Access Compliance Report

Public Rights-of-Way

Intersection ID: 10037850	Main Street: SHARON_RD	Cross Street: N/A	Location: SW
ADA ID: 536AA1A416F6	Ramp Type: MedianPerp	Initial Pass/Fail: Fail	Overall Compliance: No
		Severity Score: 10

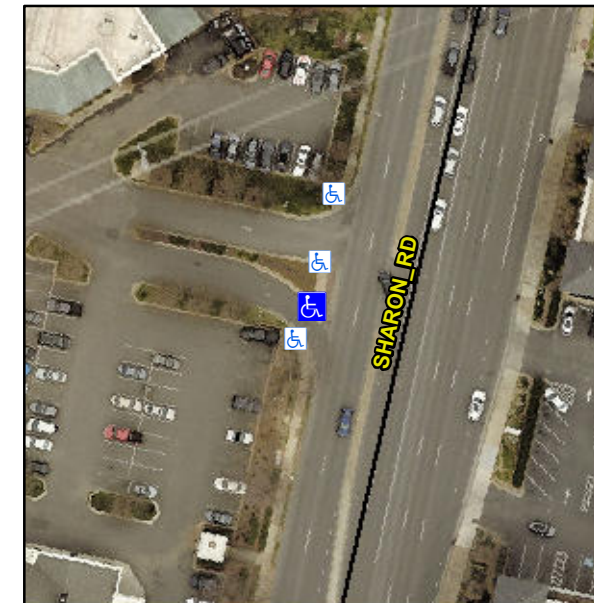
Not Found, R304.5.1, R304.5.3

Compliance	Description	Data	Compliance	Description	Data
N/A	Ramp Length (in)	72.0	Yes	Ramp Slope (%)	5.2
No	Ramp Width (in)	45.0	No	Ramp XSlope (%)	2.4
N/A	Flare Type LT	N/A	N/A	Flare Type RT	N/A
N/A	Flare Slope LT (%)	N/A	N/A	Flare Slope RT (%)	N/A
N/A	Flare Traversable LT?	N/A	N/A	Flare Traversable RT?	N/A
N/A	Landing Length (in)	N/A	N/A	DWS Provided?	N/A
N/A	Landing Width (in)	N/A	N/A	DWS Contrast?	N/A
N/A	Landing Slope (%)	N/A	N/A	DWS Length (in)	N/A
N/A	Landing X Slope (%)	N/A	N/A	DWS Full Width?	N/A
N/A	Landing Curb? (Y/N)	N/A	N/A	DWS Offset (in)	N/A
N/A	Shared Landing?	N/A			
N/A	Gutter Ponding?	N/A	N/A	Gutter Slope (%)	N/A
N/A	Gutter Lip Ht (in)	N/A	N/A	Gutter X Slope (%)	N/A
N/A	Painted X Walk1?	No	N/A	Painted X Walk2?	N/A
	X Walk 1 Direction	To S		X Walk 2 Direction	N/A
N/A	X Walk 1 Width (in)	N/A	N/A	X Walk 2 Width (in)	N/A
	X Walk 1 Slope (%)	1.3		X Walk 2 Slope (%)	N/A
	X Walk 1 X Slope (%)	0.3		X Walk 2 X Slope (%)	N/A

Remove & Replace Entire Ramp.
